SUBJECT: EPA Response to Legacy Site Services' September 12, 2014 Notice Seeking Formal Dispute Decision; Arkema Inc. Portland Facility
Administrative Order on Consent for Removal Action
U.S. EPA Region 10 Docket No. CERCLA 10-2005-0191

EPA RESPONSE TO LSS ADDITIONAL DISPUTE POSITIONS DATED SEPTEMBER 12, 2014.

Key Milestones

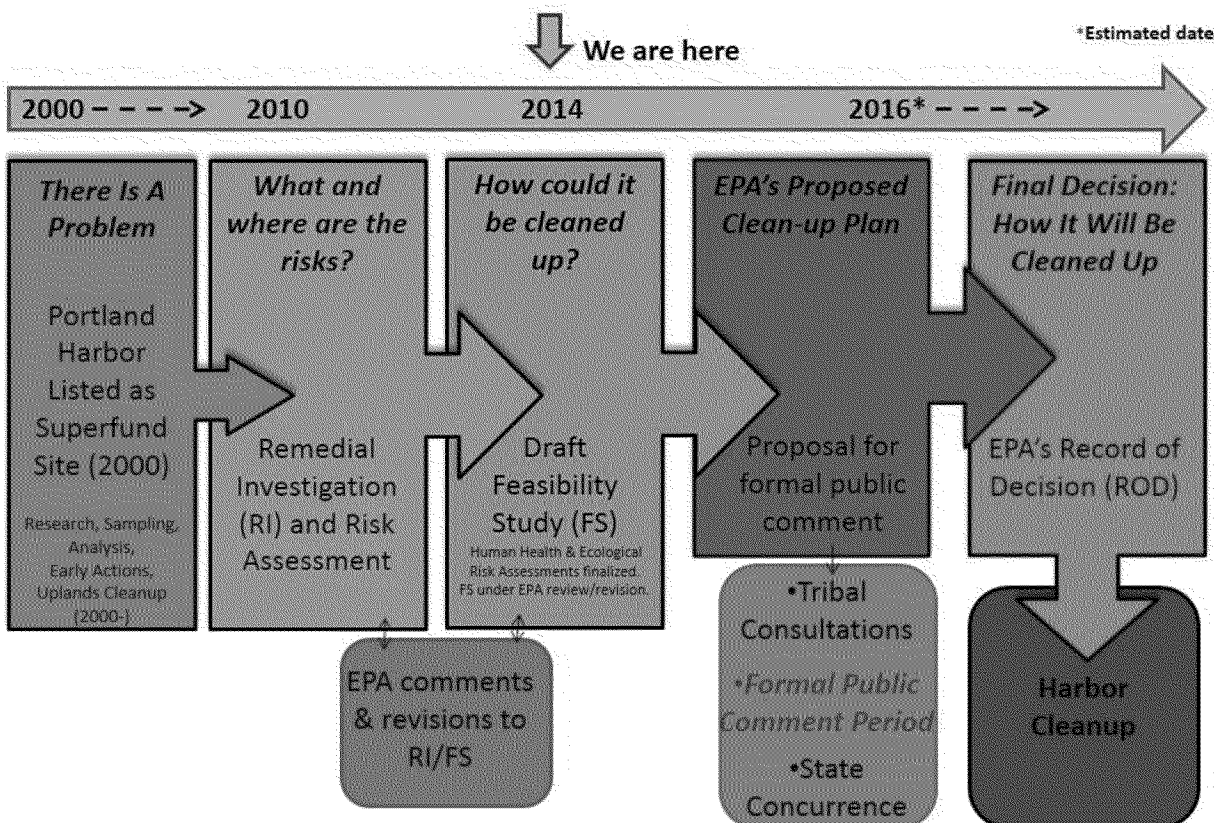
EPA has been clear with Arkema that additional data to design a protective remedy will be necessary at the Arkema site. We would greatly appreciate Arkema's enthusiasm to agree to begin to collect design samples under an amended order with EPA. However, to stay on the aggressive schedule we have set for finalizing the RI/FS and publishing a proposed plan for the Portland Harbor Superfund Site, EPA's time and attention needs to be devoted to accomplishing that result and any additional design sampling would not be on a schedule tied to completion of the RI/FS.
